LIGO- T030223-00-D

ADVANCED LIGO

Review of basic shorting tests on Coil Formers **D020188-04** and **D020188-08**

- 1) Test: Rubbing of Kapton wire over the edge of the main channel

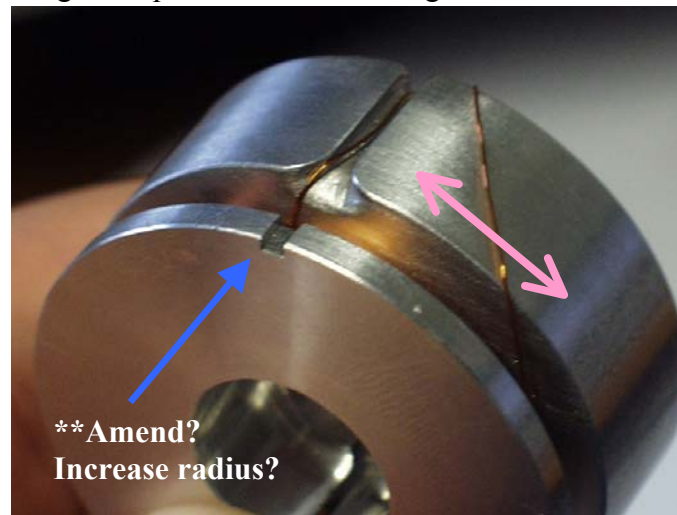
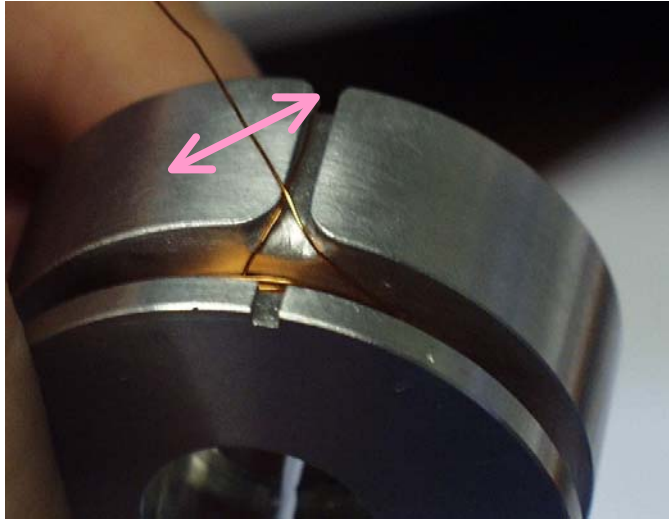
This scenario is unlikely to cause a short during the winding given the winding set-up here at the Institute for Gravitational Research (Glasgow), as the wire is generally parallel to the walls of the channel during winding. However, if the winding responsibilities are transferred to the team at the California Institute for Technology (as is currently under discussion) it would be sensible to assess any new winding facility with respect to our Coil Former design so that any unforeseen problems can be highlighted.

I was eventually able to create a short, but this took a while. The fillets at the point of interest would appear to be adequate.

If anyone has any concerns about this scenario then we can of course increase the radius of the fillets on edges adjacent to the channel. This may be a sensible particularly on all edges that result from the slot (created to reduce eddy current effects).

- 2) Test: Rubbing of wire inside the “trumpet flute”

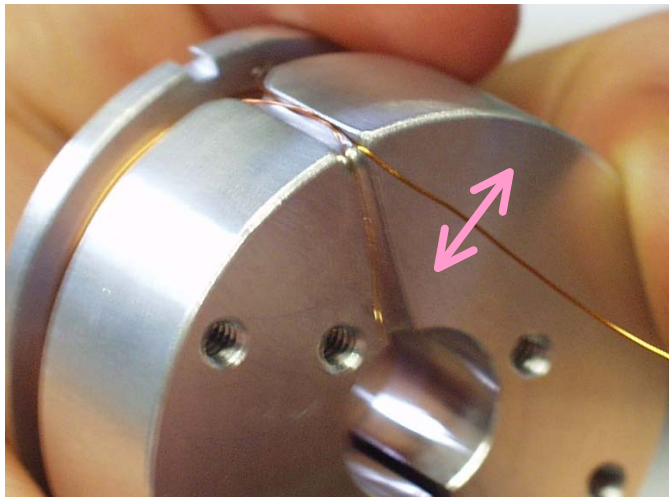
Again, this a few minutes ‘rough’ treatment to breach the Kapton coating, but the repetitive wear eventually takes effect. The introduction of this feature has made a huge difference though.

Given the importance of this feature, we should consider specifying a better surface finish in this area – and indeed on other regions of the former where repetitive wear is a possibility, whether it be during winding or otherwise.

- 3) Test: Wire coming over top and down the back path

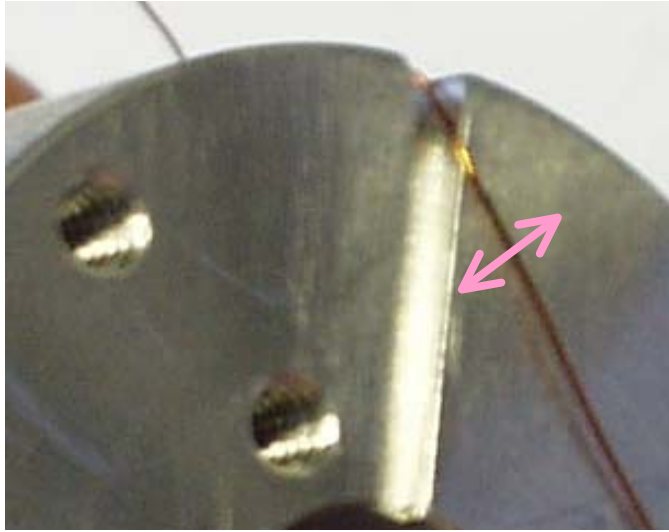
Repetitive wear again eventually caused a short.

Review engineering drawing – again in relation to fillet radius and surface finish.

- 5) Test: On edges adjacent to centre bore

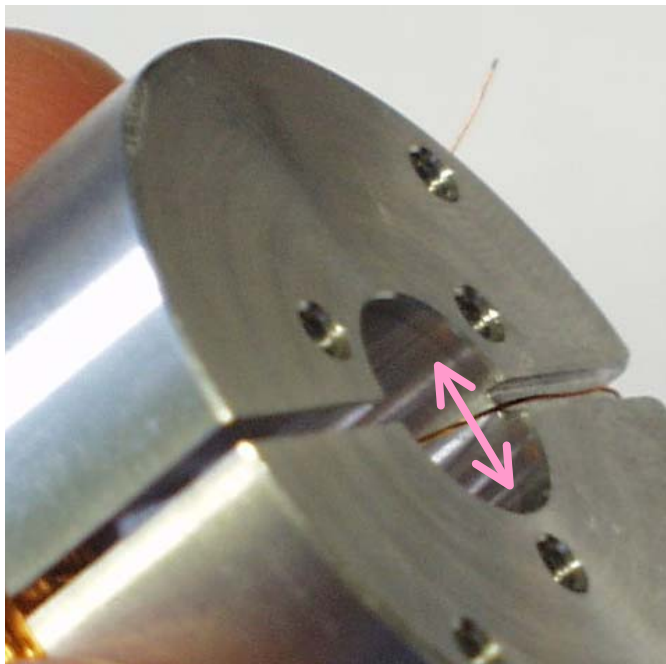
Both of the following tests had the same end result as tests 1 - 3, but shorting took less effort.

Increase fillet radius and make sure that this information is clearly communicated on the manufacturing drawing.

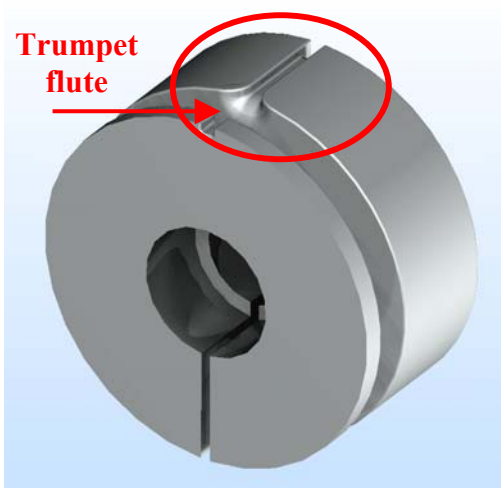
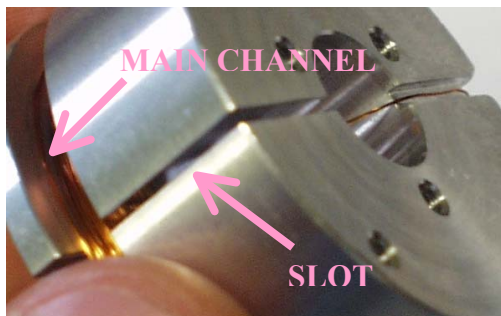
- We are also looking into the feasibility of using Kapton film in certain locations to provide further protection against the occurrence of shorting.

This is particularly relevant in locations where the wire comes into contact with the slot.

It is difficult to create fillets on edges created by the slot inside the main wire channel.

One option may be to wind some Kapton film inside the main channel prior to the winding of the copper wire as this may provide the required protection from any hard edges.

We are also considering using Kapton Film for a similar purpose, an extra layer of protection as the wire passes out the main channel, over the “trumpet flute” and down through the back pathway.
